P032 Airly .L1.
9 July 2014

RE: AIRLY MINE EXTENSION OF TIME

1. INTRODUCTION

Figure 1: From EA Appendix 2, annotated by Pells Consulting according to the Legend on the drawing

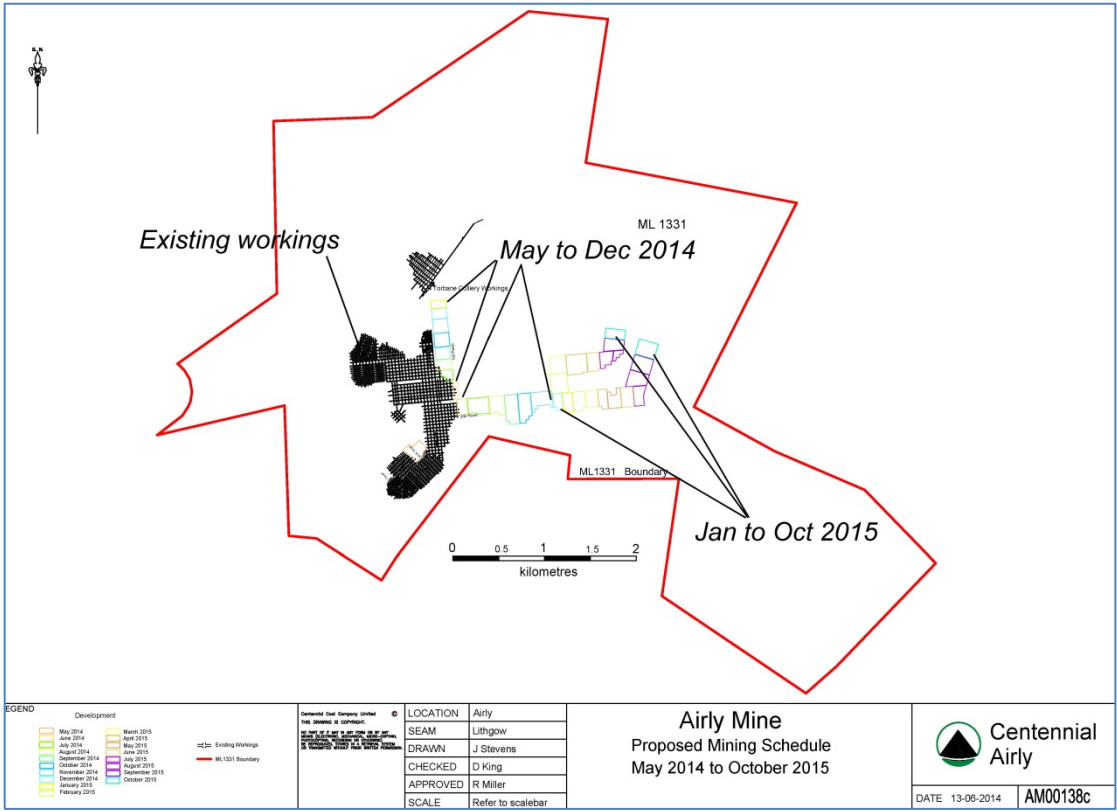
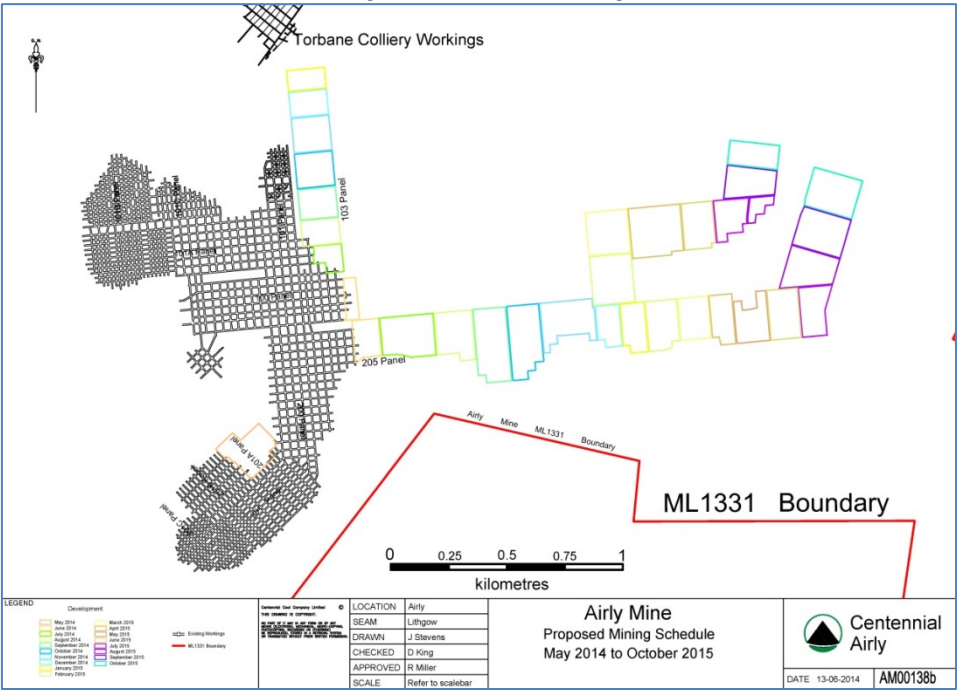
It is our opinion that there is a probably a typographical error in the above quotation from the Environmental assessment in that the first reference to 'Appendix 2' should be ti Appendix 3. The actual Appendix 2 contains two figures, reproduced below. The second is an enlargement of part of the first.

Figure 3: proposed mining in relation to existing Environmental Protection Zones.

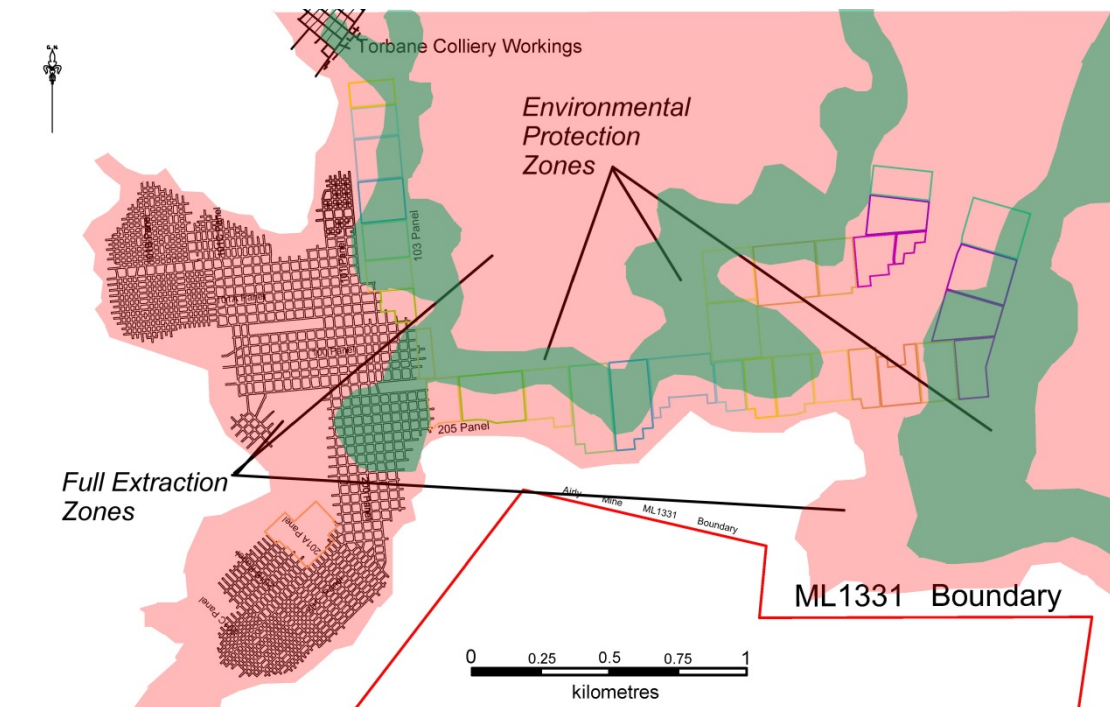
We note that the two figures reproduced above do not show the Environmental Protection Zones. In order to determine these in relation to the proposed workings we have superimposed Drawing 5 from the EA onto Figure 2 as reproduced above. The result is given in Figure 3, below.

It can be seen that substantial portions of the proposed workings will be in areas of allowable total extraction wherein subsidence may be up to 1.8m, tensile strains up to 25.5mm/m, compressive strains to 42.5mm/m and tilts up to 85mm/m.

Figure 4: Panels analysed by Golder Associates superimposed on proposed mine plan from EA

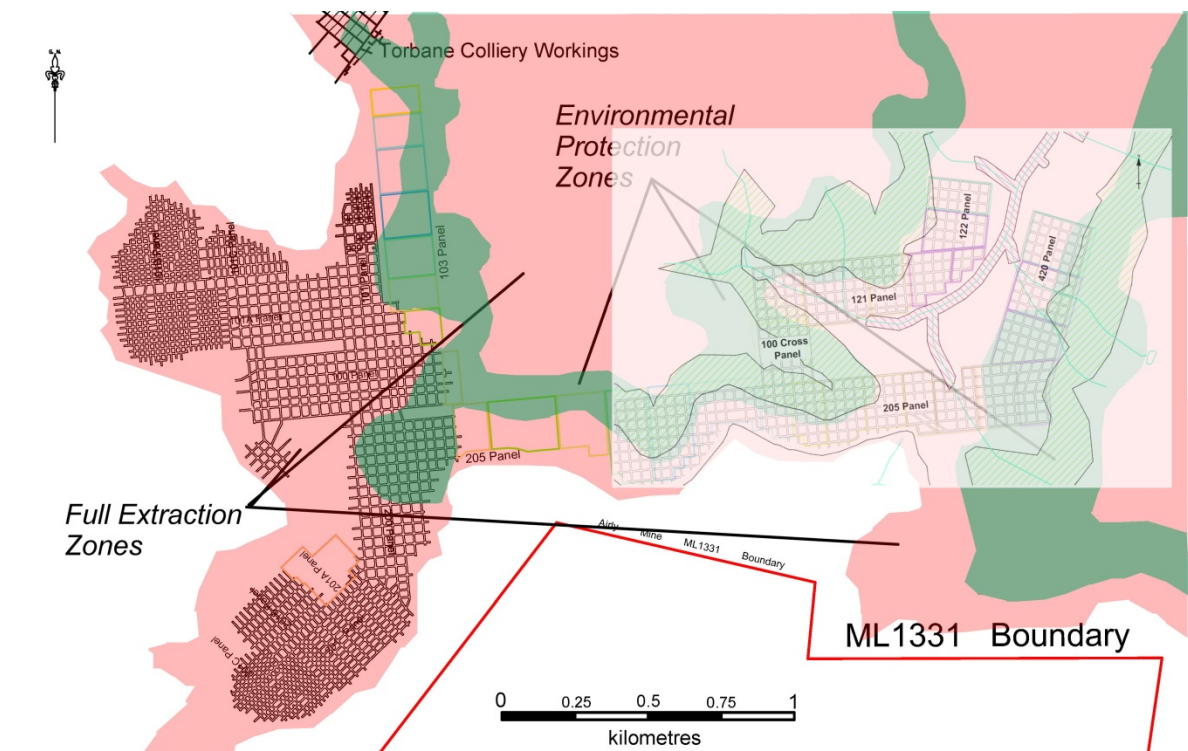
The obvious point that arises from Figure 4 is that the analyses undertaken by Golder Associates, that are stated as covering the whole of the proposed mine area, do not do so. They cover none of the area on the west and north-west, which are almost entirely under Environmental Protection Area.

The less obvious point is that an examination of the Golder document reveals that it provides no analyses of mining in areas where “Full Extraction” is allowed. The Golder analyses only apply to first workings where pillar factors of safety have been chose so as to limit surface tensile strains to $<1\text{mm/m}$, with trivial surface settlement.
